Docket No. #22-ZONE-0098

Blankenbaker Station Community
Association, Inc. concerns related to the
zone change at property located at 1525-
1711 Tucker Station Road,
12850 & 1704 S. Pope Lick Road

PLANNING COMMISSION PUBLIC HEARING

CHANGE IN ZONING FROM R-4 TO PEC
CASE # 22-ZONE-0098

RIGHT-OF-WAY EXTENSION

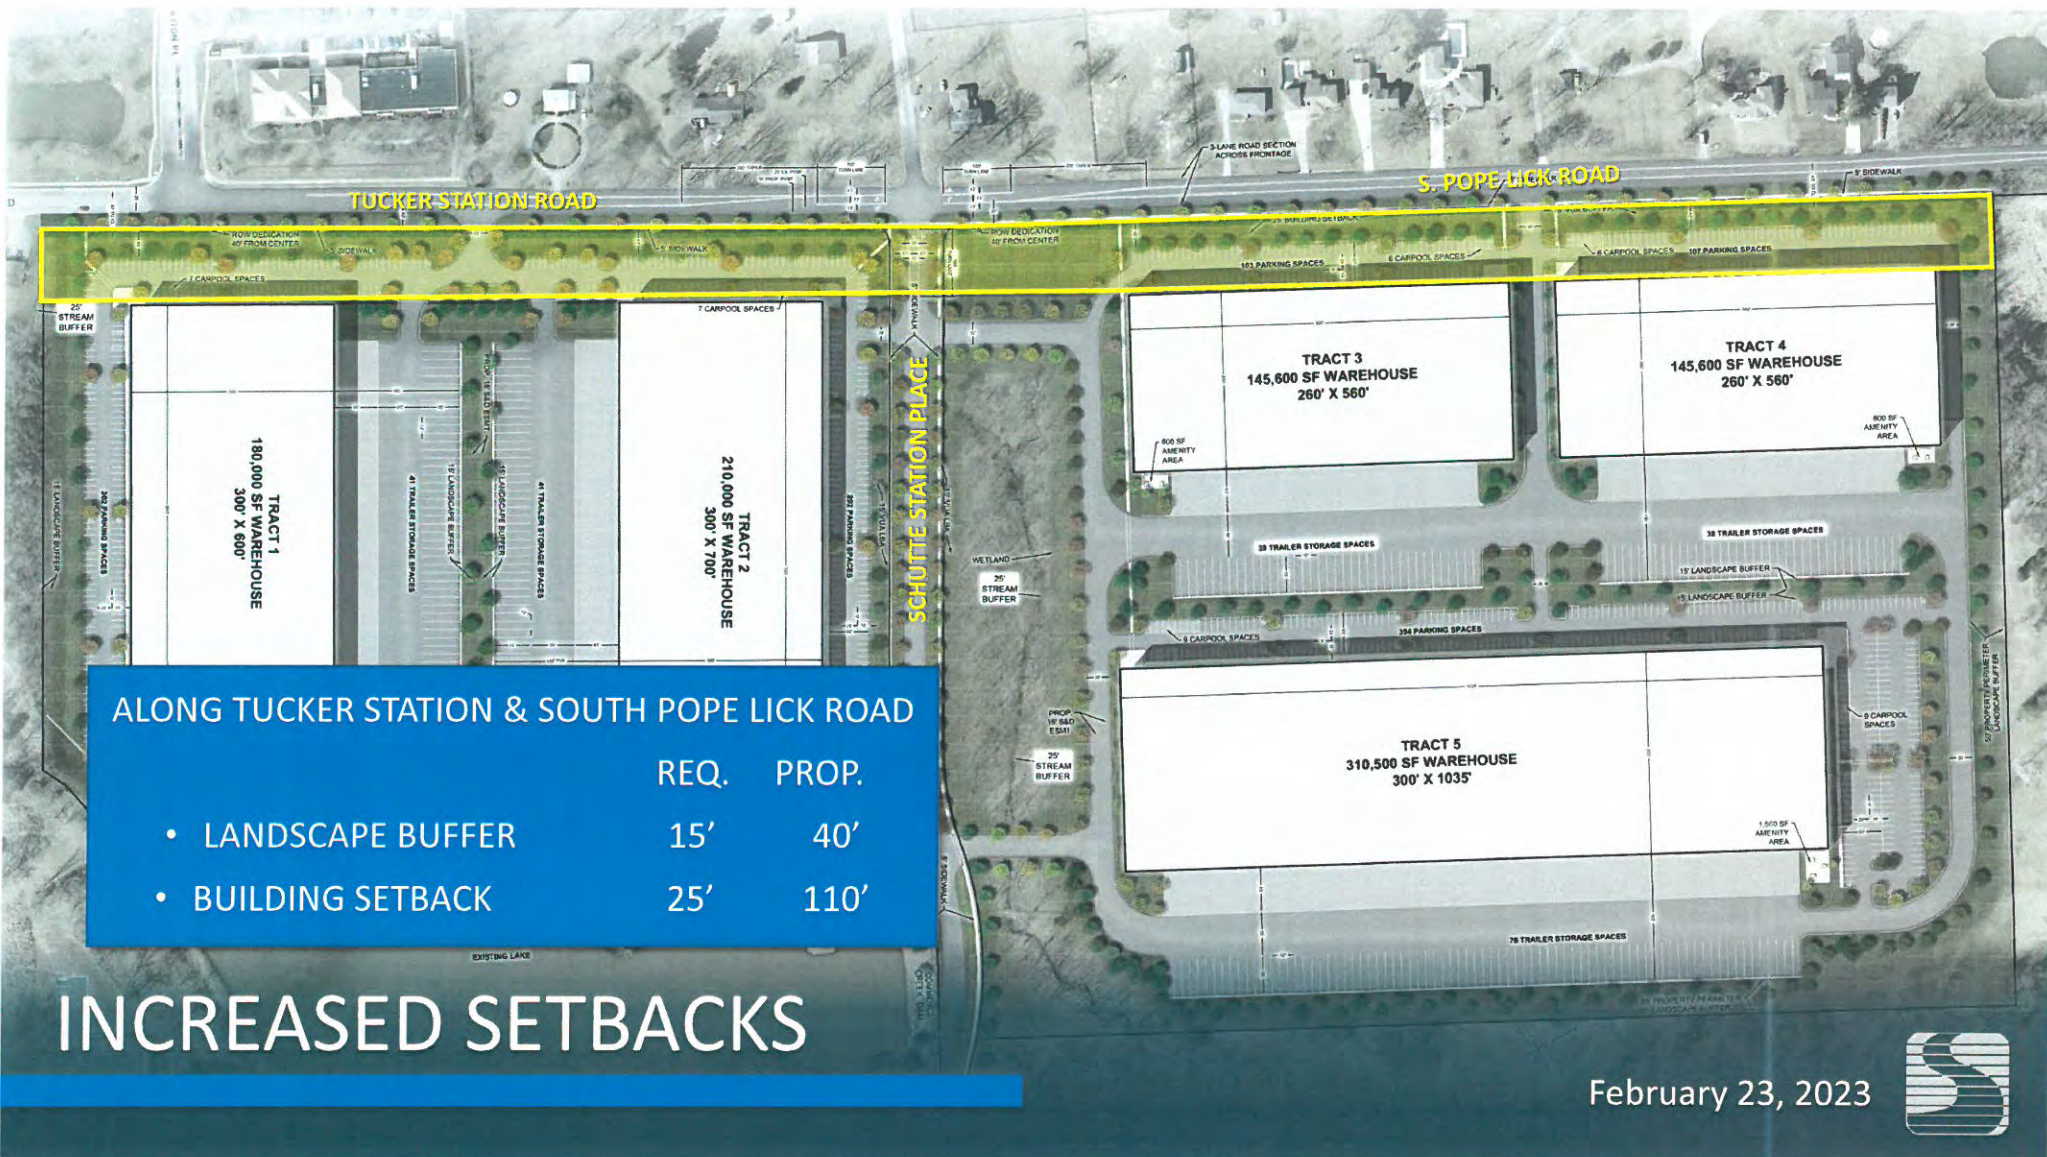
- 2) Does Xebec have a conceptual plan (alignment/profile) of how the proposed Schutte Station Place will be constructed? This has been requested numerous times by the Planning Commission with only an engineer letter opining that a connection to Schutte Station Place is technically feasible having been provided to date. The Xebec LD&T presentation indicates additional right-of-way is required from the Association and/or the adjacent business owner in order for the connection at Schutte Station Place to be completed (pasted below), but no agreements have been reached with the Association or the adjacent business owner:

2. *Does Xebec have a conceptual plan (alignment/profile) of how the proposed Schutte Station Place will be constructed? This has been requested numerous times by the Planning Commission with only an engineer letter opining that a connection to Schutte Station Place is technically feasible having been provided to date. The Xebec LD&T presentation indicates additional right-of-way is required from the Association and/or the adjacent business owner in order for the connection at Schutte Station Place to be completed, but no agreements have been reached with the Association or the adjacent business owner.*

Response: The proposed alignment for the Schutte Station Place connection is clearly shown on the development plan that is a part of the record of this case and publicly available online via the Louisville Metro Business Portal. The LD&T Committee asked for assurances that the

Schutte Station Place connection could physically be made. To address this concern, Xebec hired a structural engineer to analyze the existing site conditions and make recommendations on whether the connection was reasonably feasible and how it might be constructed. As stated in the letter from American Engineers on February 21, 2003, "AEI feels an engineered solution is possible and constructible with more than one possible solution." A copy of this letter was provided for the case file. We do not have a road profile to share at this time. We are currently in the development plan stage of this project and have not begun construction drawings, as is typical with developments in Jefferson County. A preliminary grading study has been conducted to provide approximate finished floor elevations for the proposed buildings in order to prepare illustrative exhibits to present at LD&T, but full grading and drainage plans have not been prepared, and won't be until zoning approval is obtained.

As we indicated at various LD&T and neighborhood meetings, the extension of Schutte Station Place will require that a portion of the Association's property to the immediate south of the project site be dedicated as right-of-way. The rest of the property required for the extension will be provided from property that Xebec is acquiring. In Case No. 16ZONE1090, the development plan for the Association's property at issue shows a 63-foot strip of such property as "reserved for future R/W," and Binding Element No. 6 states: "*Right of way for the extension of Schutte Station Place, if not already constructed as determined by Metro Public Works, shall be dedicated by the HOSTS Development within 60 days of the request from the Director of Public Works or at the time of the Developer's request for a major subdivision plat.*" This binding element requiring dedication of the right-of-way for the extension of the road is binding on the Association. In fact, Xebec has elected to swing the proposed road alignment further into the property it is acquiring and away from the pond on the Association property, so less of the Association's property will be used for right-of-way than is required to be dedicated under Case No. 16ZONE1090.

ROAD IMPROVEMENTS

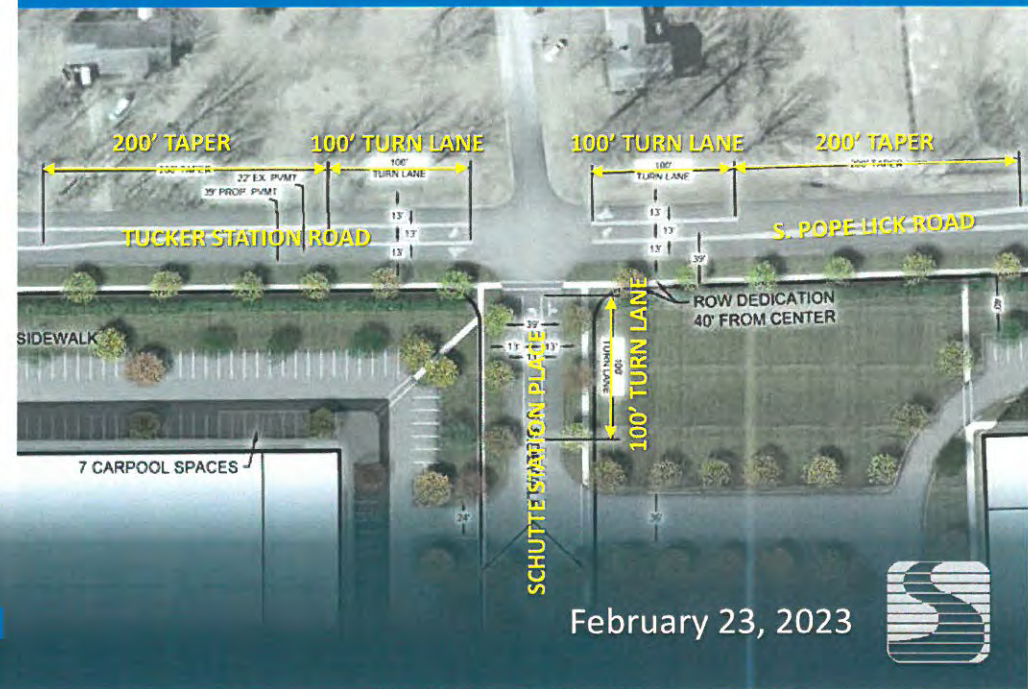
- Tucker Station Road frontage should be widened to 4 lanes with a median similar to Plantside Drive and Bluegrass Parkway
- Schutte Station Place connection to be constructed prior to the Certificate of Occupancy for the first building
- Viewscape of the \$100M+ in office buildings on the Blankenbaker Station side of the lake (tree preservation, additional landscaping, etc.)

- The applicant shall widen Tucker Station Road & South Pope Lick Road to ~~three~~ **FOUR** lanes across the frontage of the property and add turn lanes at the South Pope Lick/Tucker Station/Schutte Station intersection as presented at the Public Hearing on May 25th, 2023. This work shall be completed prior to a certificate of occupancy being issued for the ~~second~~ **FIRST** building.

Response: As stated in our LD&T meetings, Xebec will be installing turn lanes eastbound, westbound, and northbound at the Tucker Station/South Pope Lick/Schutte Station intersection. There isn't enough right-of-way available to install turn lanes in the southbound direction. Xebec will also be widening Tucker Station and South Pope Lick to three lanes for approximately 2,300 feet from the end of the existing three lane section across the frontage of the property in accordance with Metro Public Works requirements. We do not believe that there is any precedent for imposing on Xebec a binding element that restricts all construction approvals until all road improvements are complete. However, Xebec would be willing to agree that the road improvements be completed prior to certain stages of the development as described in the proposed binding elements included with this letter.
